| Serial No. 07/411,576 |) | |
| For: MINIATURE FLASHLIGHT |) | |

THIRD AMENDMENT AFTER FINAL REJECTION

Fig. 1

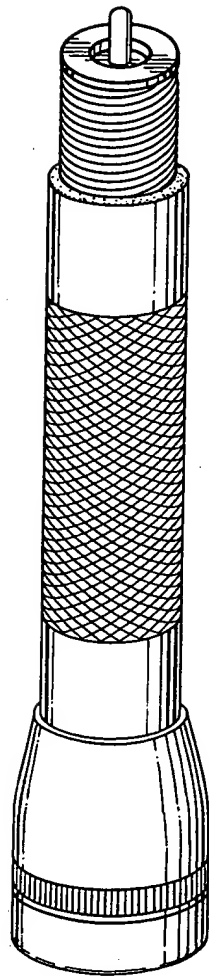
The stippling was questioned on the O-ring. Reference was made to page 8 of the original specification where the O-ring was presented and indicated to be for sealing. It was felt that the representation with the stippling was appropriate. It also appeared on Figure 1 of the first formal drawing.

Fig. 2

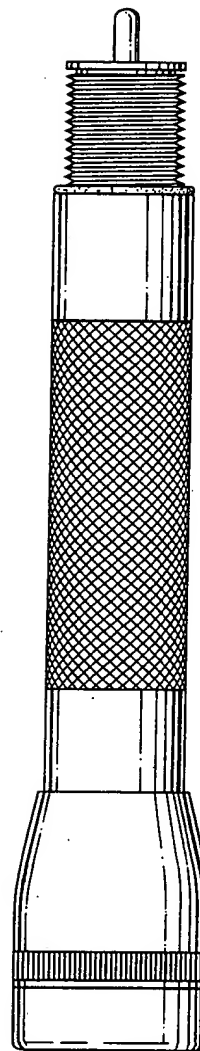
Rather than simply attempt to further sketch changes, the Applicant has prepared a formal drawing. The drawing is intended to include everything submitted in the past as well as reflect the comments from the interview. During the interview, the relative diameter of the threaded portion of the barrel compared with the main portion of the barrel was discussed. The Examiner wanted this relative size to be like the first formal drawing presented in the present application. As noted in the Substitute Declaration of Gerald R. Parker, this has been done.

Applicant is intending to reduce as many issues as possible to leave the single issue of the shape of the flashlight head, i.e., curved versus angled. The relative diameter of the threaded and unthreaded portions of the barrel are according to the Examiner's wishes. The diameters of the added rings in Figures 3 and 4 reflect the shapes in Figures 1 and 2. The threads have been appropriately oriented. Consequently, the drawings are believed to be acceptable with the exception of the head portion as mentioned above.
